**PROCUREMENT SERVICES  
ADDENDUM**

<b>Date of Notice:</b>	4/22/2025
<b>Solicitation No.:</b>	IB-024-25
<b>Title:</b>	HSC Bldg. 56 Kentucky Lions Eye Atrium Resealing and Waterproofing
<b>Addendum No.:</b>	1

SHEET TITLE:  
EAST ELEVATION

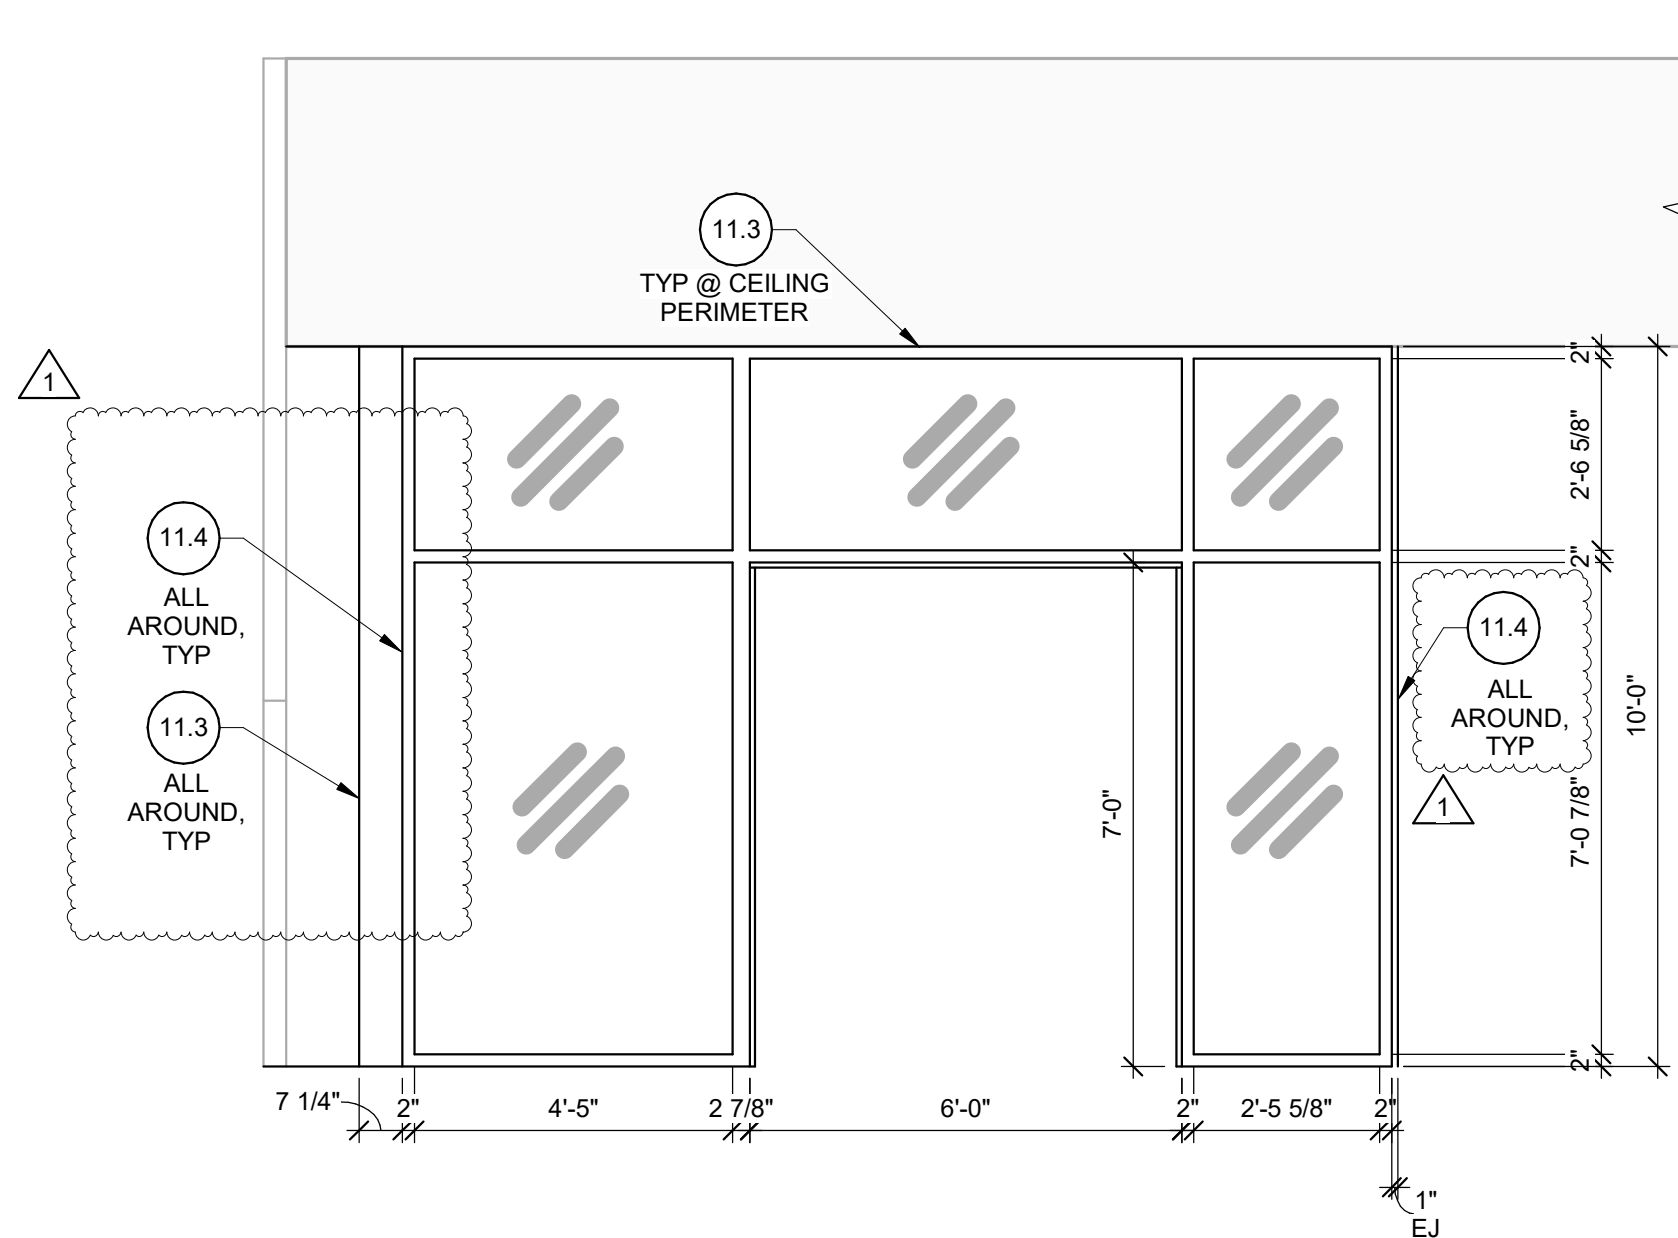
- 1. Drawing Sheet R-102– East Elevation
  - 1) Work Items near the entrance doors on the East elevation were changed from W.I. 10.1, to Work Items 11.4 or 11.3. These new items are typical all around the entrance.
- 2. Drawing Sheet R-103 – South Elevation
  - 1) Work Item 10.1 was removed from the South entrance doors on the left side, and on the right was replaced with Work Item 11.4.
